Re: Dandelion Draw Channel Improvements at High Point–Infrastructure Site Plan  
Martin/Martin, Inc. Project No.: 19.1043  
City of Aurora, Application Number: DA-1746-35

# DANDELION DRAW CHANNEL IMPROVEMENTS AT HIGH POINT SITE PLAN AND DLD1 E. 68TH AVE. TO E-470

DANDELION DRAW  
 INFRASTRUCTURE SITE PLAN  
 COVER SHEET

Sheet Number:  
**LANDSCAPE PLAN**  
7

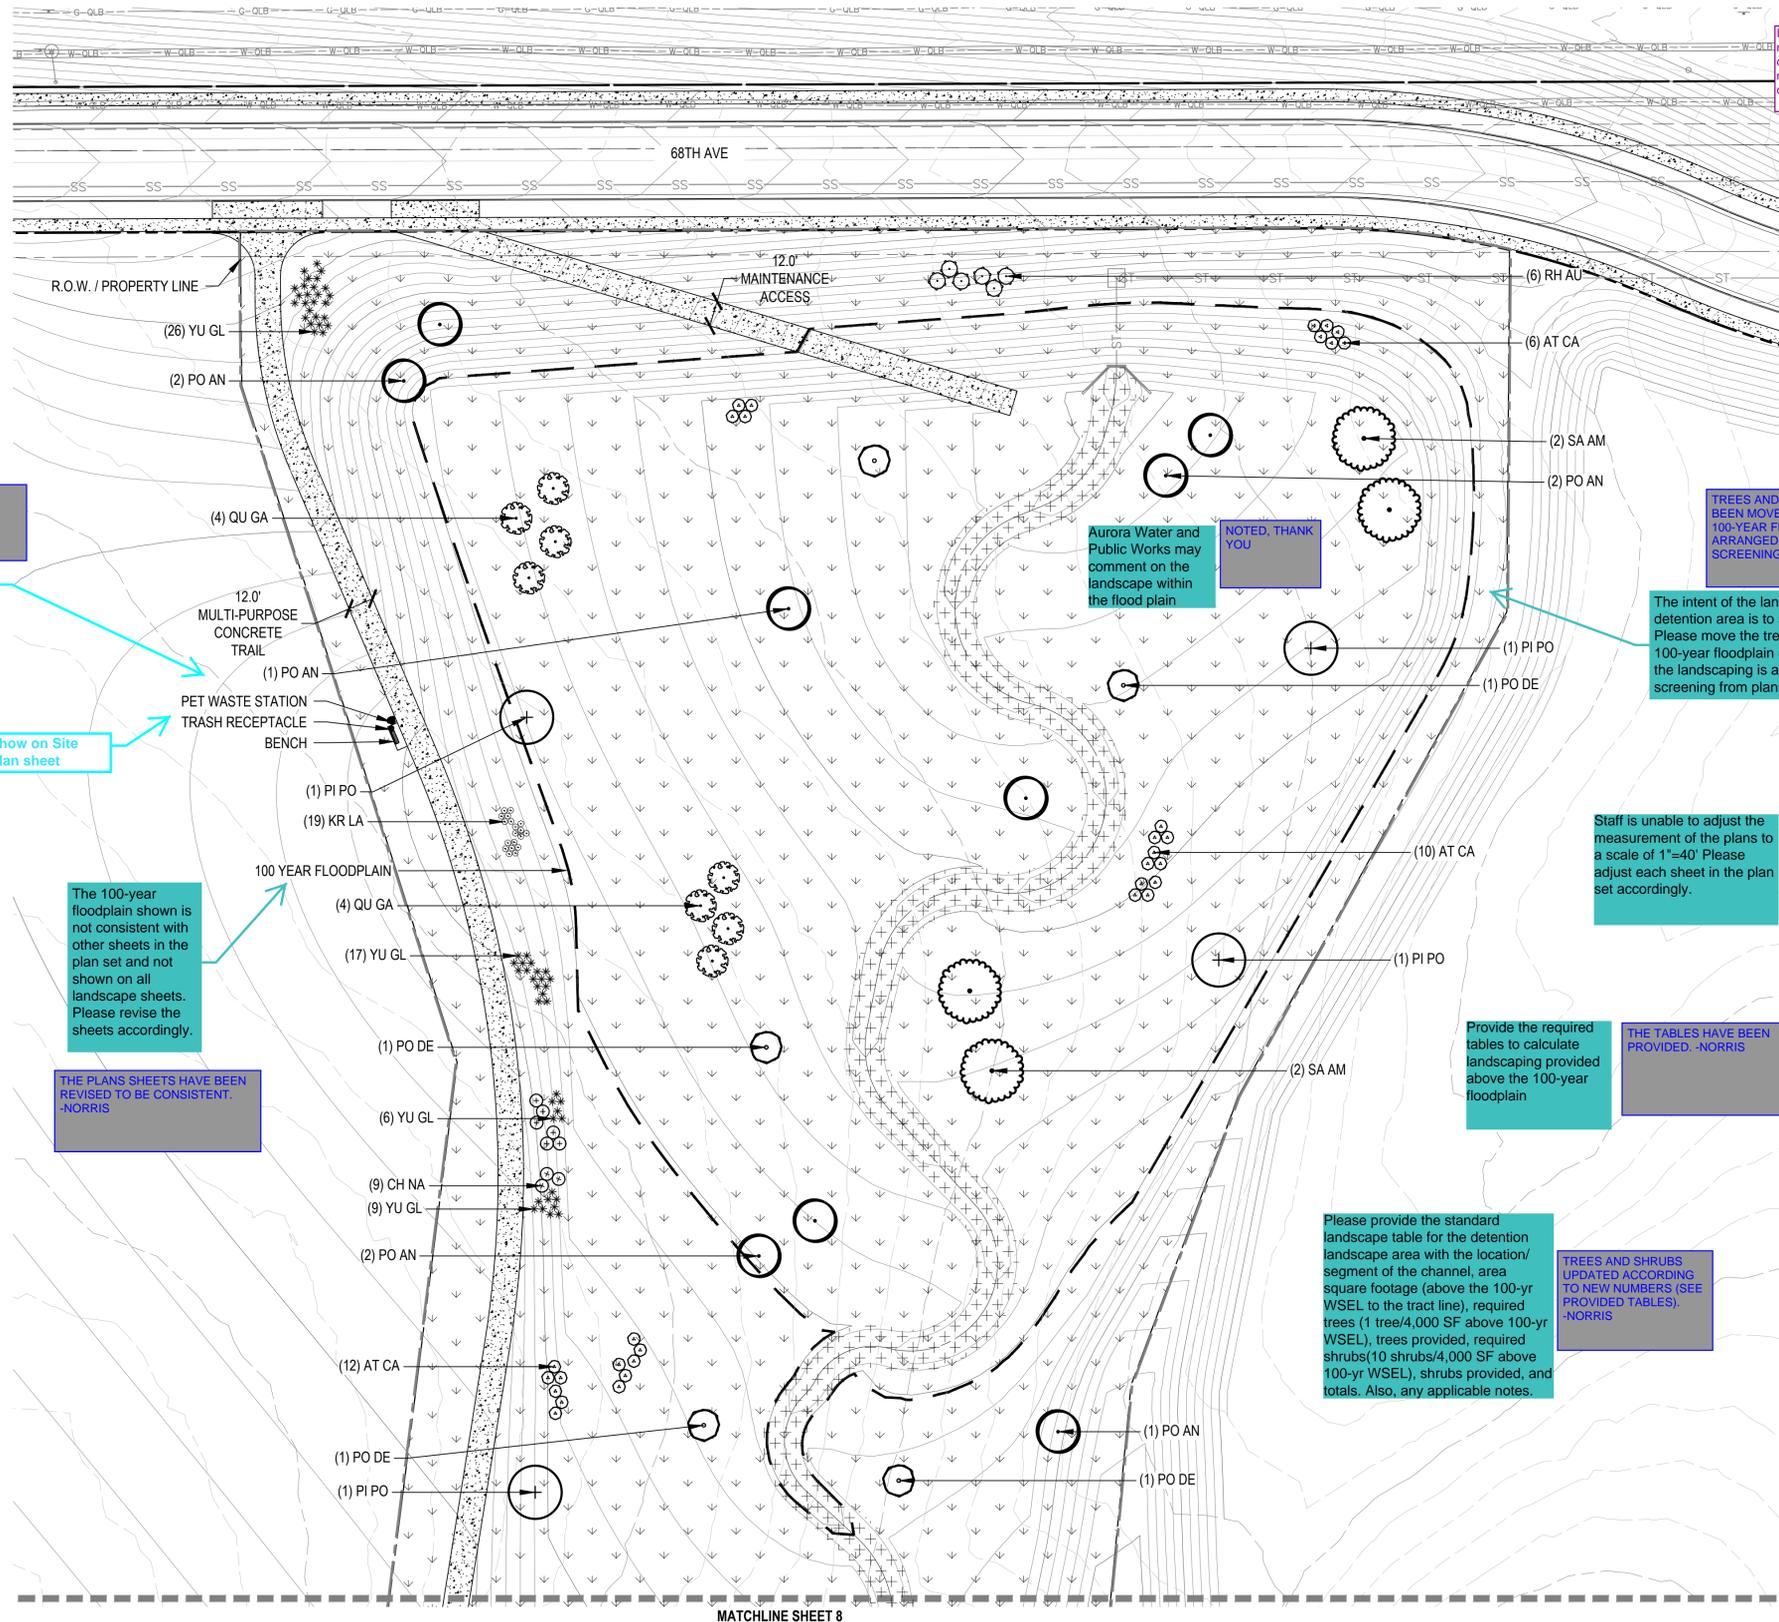
It does not appear, based on the newly updated open space map and Form J that this area is trying to receive open space credit for this area. If not, additional trail connection would need to be provided to at minimum loop the channel area and connect to proposed PA-70 to be constructed with PA-30a.

The 100-year floodplain shown is not consistent with other sheets in the plan set and not shown on all landscape sheets. Please revise the sheets accordingly.

Aurora Water and Public Works may comment on the landscape within the flood plain

The intent of the landscaping surrounding the detention area is to screen it from view. Please move the trees and shrubs above the 100-year floodplain elevation and make sure the landscaping is arranged to provide screening from planned adjacent uses.

Staff is unable to adjust the measurement of the plans to a scale of 1"=40'. Please adjust each sheet in the plan set accordingly.

Provide the required tables to calculate landscaping provided above the 100-year floodplain

Please provide the standard landscape table for the detention landscape area with the location/segment of the channel, area square footage (above the 100-yr WSEL to the tract line), required trees (1 tree/4,000 SF above 100-yr WSEL), trees provided, required shrubs (10 shrubs/4,000 SF above 100-yr WSEL), shrubs provided, and totals. Also, any applicable notes.

THE PROJECT TEAM WILL CONTINUE TO COORDINATE THE OPEN SPACE PLAN. THE TRAIL HAS BEEN EXTENDED TO "CLOSE THE LOOP."

THE PLANS SHEETS HAVE BEEN REVISED TO BE CONSISTENT. -NORRIS

THE DRAWING SCALES HAVE BEEN VERIFIED. -NORRIS

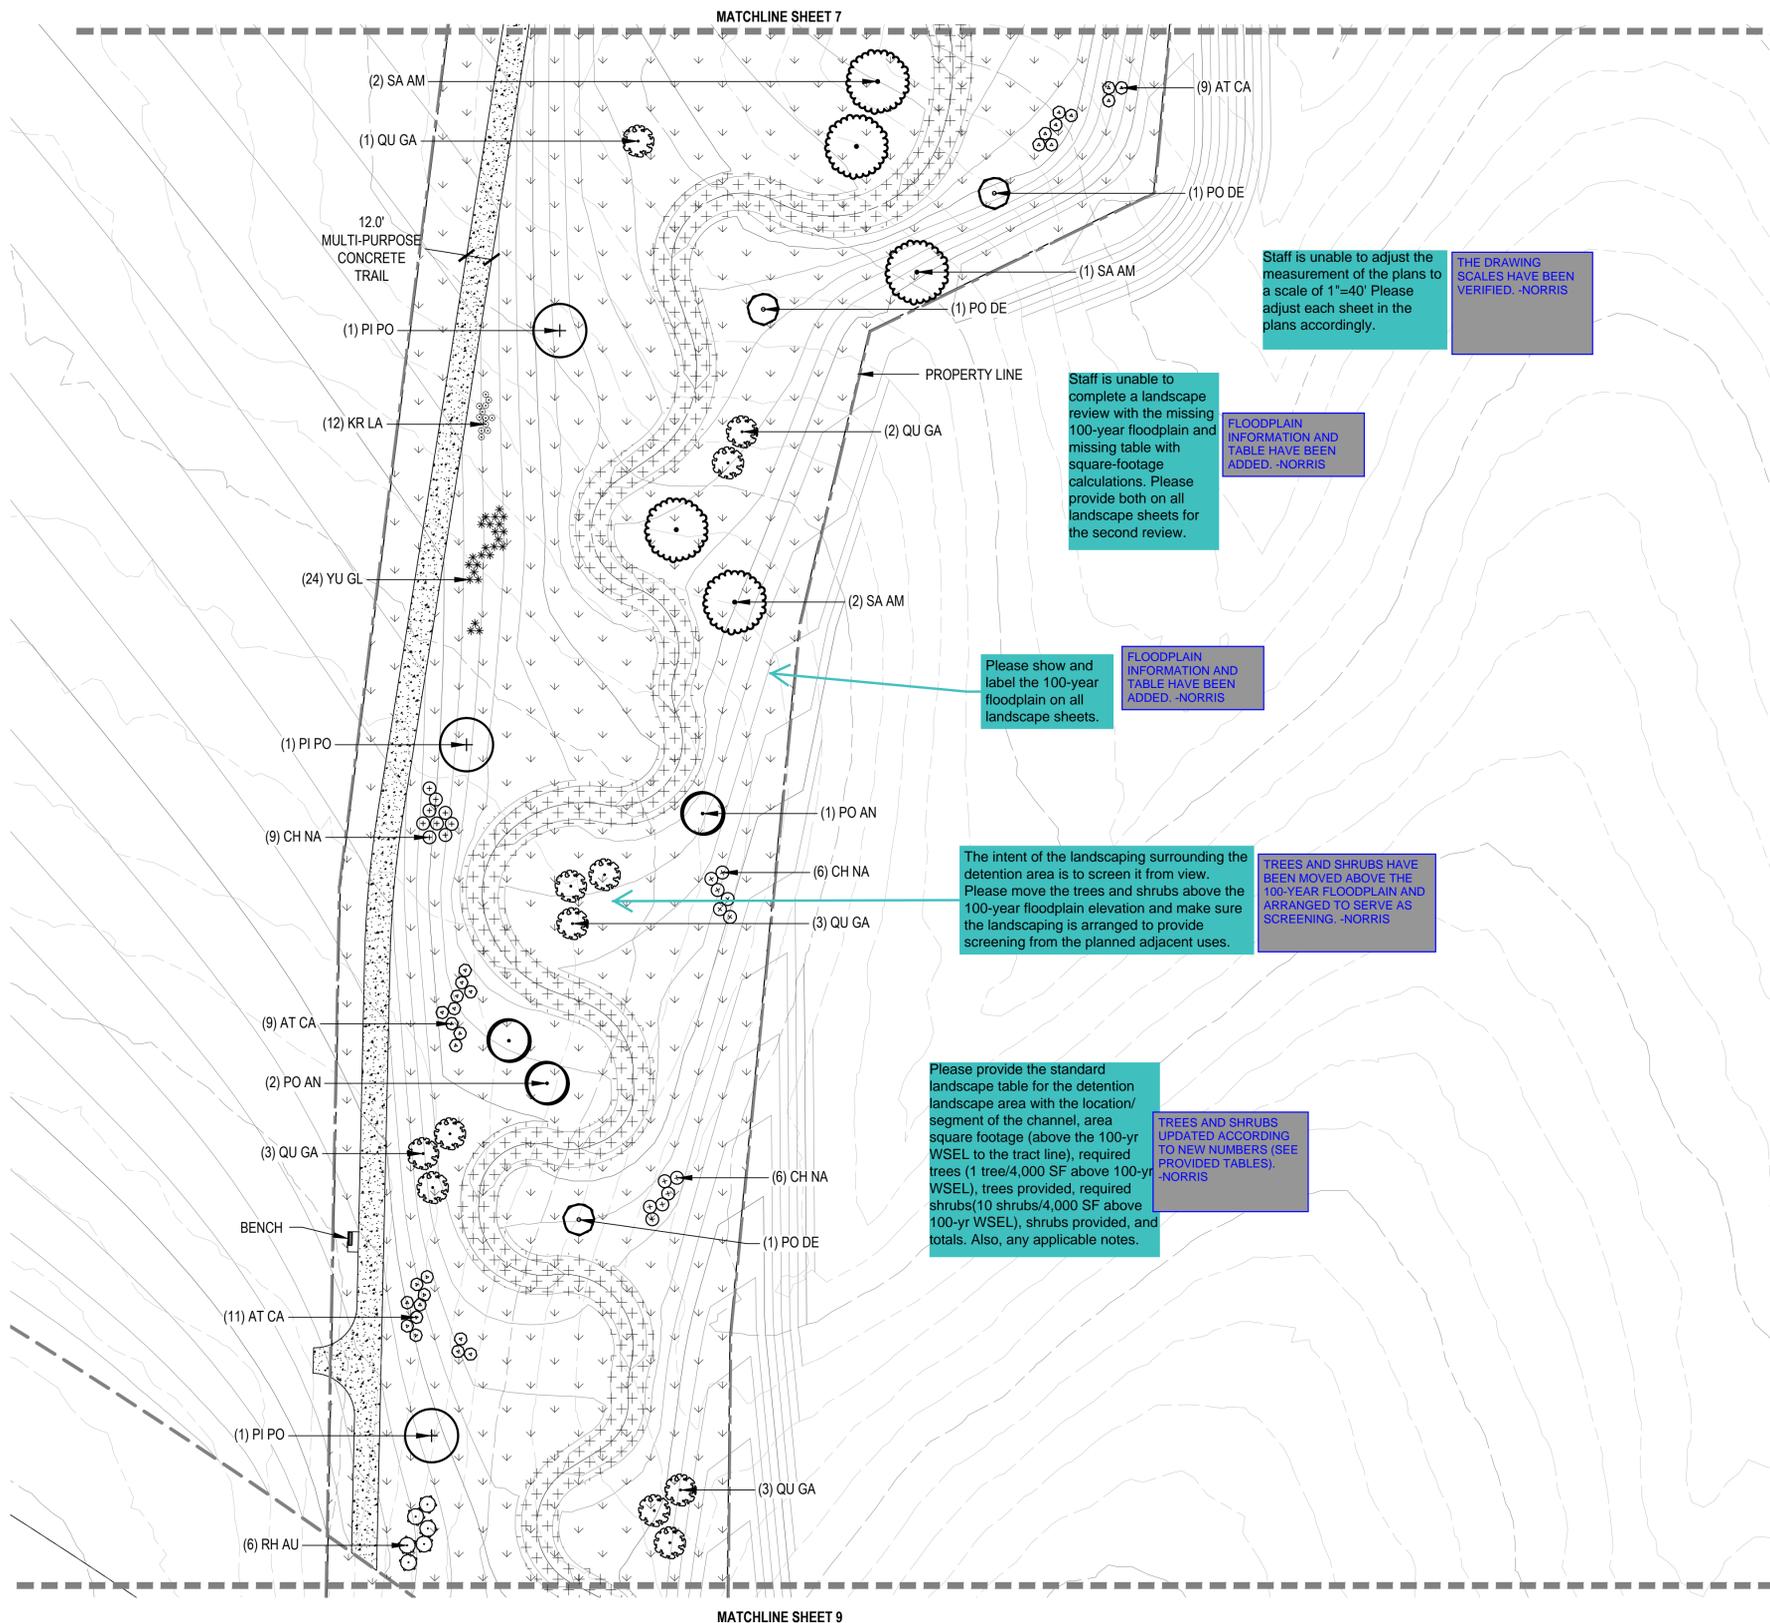
Staff is unable to adjust the measurement of the plans to a scale of 1"=40'. Please adjust each sheet in the plans accordingly.

Staff is unable to complete a landscape review with the missing 100-year floodplain and missing table with square-footage calculations. Please provide both on all landscape sheets for the second review.

Please show and label the 100-year floodplain on all landscape sheets.

The intent of the landscaping surrounding the detention area is to screen it from view. Please move the trees and shrubs above the 100-year floodplain elevation and make sure the landscaping is arranged to provide screening from the planned adjacent uses.

Please provide the standard landscape table for the detention landscape area with the location/segment of the channel, area square footage (above the 100-yr WSEL to the tract line), required trees (1 tree/4,000 SF above 100-yr WSEL), trees provided, required shrubs (10 shrubs/4,000 SF above 100-yr WSEL), shrubs provided, and totals. Also, any applicable notes.

THE DRAWING SCALES HAVE BEEN VERIFIED. -NORRIS

FLOODPLAIN INFORMATION AND TABLE HAVE BEEN ADDED. -NORRIS

FLOODPLAIN INFORMATION AND TABLE HAVE BEEN ADDED. -NORRIS

TREES AND SHRUBS UPDATED ACCORDING TO NEW NUMBERS (SEE PROVIDED TABLES). -NORRIS

Sheet Number:  
**LANDSCAPE PLAN**  
**9**

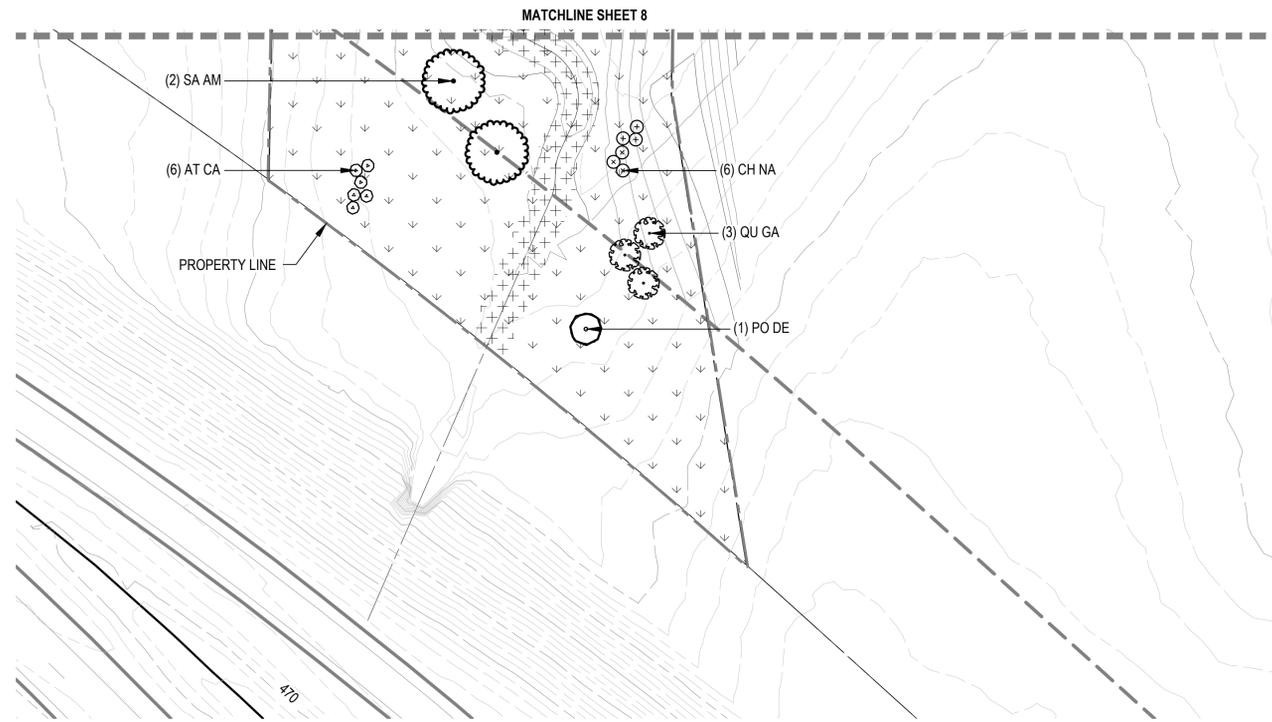
C13A.9: Sheet 9 shows seeding and plantings along channel in the MUE. Tree plantings in the MUE along the highway will be limited to the outer 25' feet.

**R13A.9: All landscaping will be in accord with MHFD and COA requirements. Refer to the landscape plans for tree planting details.**
